A REPAIR (09006)

## ON-SITE SEWAGE DISPOSAL SYSTEM HOWARD COUNTY HEALTH DEPARTMENT BUREAU OF ENVIRONMENTAL HEALTH

SUBDIVISION: Burntwoods LOT NUMBER: 10-B

ADDRESS: 13910 Castlebar Drive PROPERTY OWNER: Fleck

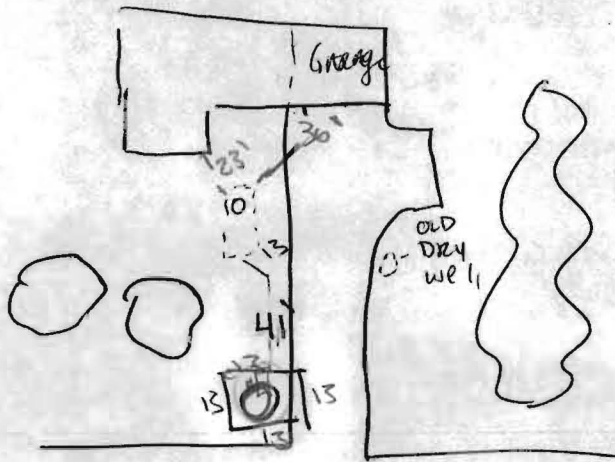
TRENCHES:	Trench to be _____ feet wide. Inlet _____ feet below original grade. Bottom maximum depth _____ feet below original grade. Effective area begins at _____ feet below original grade. _____ feet of stone below distribution pipe.
LOCATION:	<u>inlet @ 3' bottom @ 13'</u> <u>13x13x13 dry well "pit" 9" concentric rings</u>
PURPOSE:	Existing septic system has failed. Call for inspection when ground is opened so sanitarian can recommend repair. <u>Replace baffles &amp; place manhole riser</u>

PRE-CONSTRUCTION Existing septic sys. located per plan. Excavated replacement dry well area. Surrounding wells not an issue for repair

INSTALLATION Filler dry well w/ stone for future hook-up.

10/5/05 - Old dry well filled w/ stone & abandoned.

Baffles added to old tank. Dry well installed to plan

OK to cover after last load of stone is

dumped to allow stone to be flush w/ dry well lid.

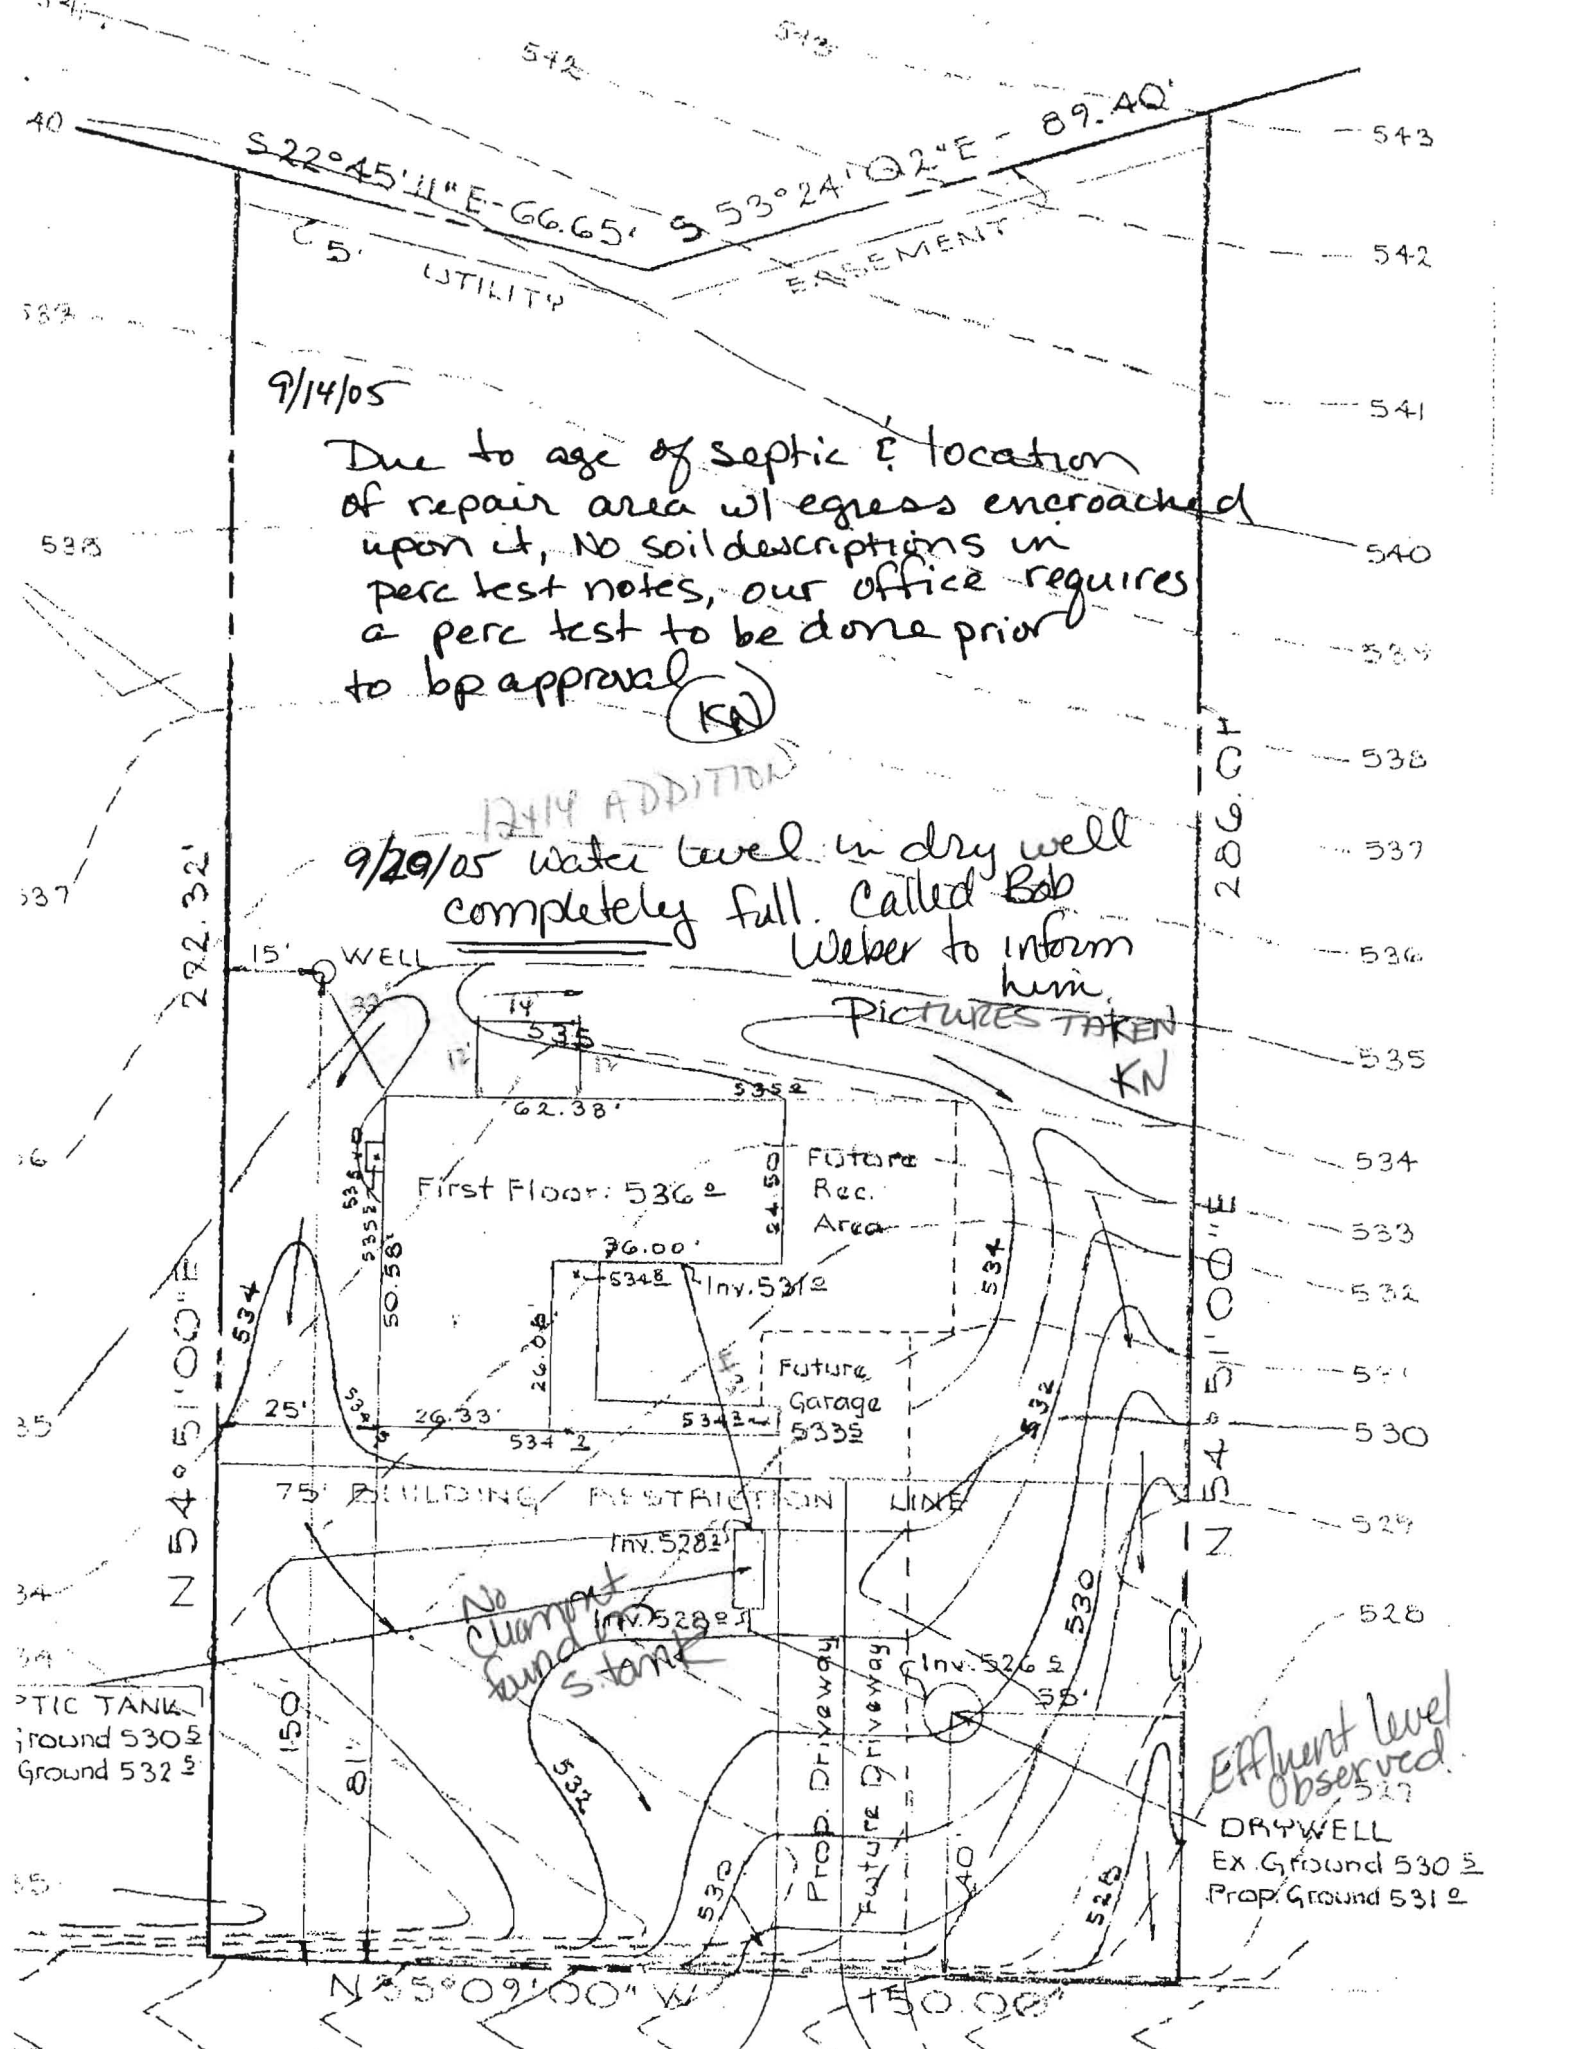
Due to age of septic & location of repair area w/ egress encroached upon it, No soil descriptions in perc test notes, our office requires a perc test to be done prior to bp approval (KN)

9/29/05 water level in dry well completely full. Called Bob Weber to inform him. Pictures taken (KN)
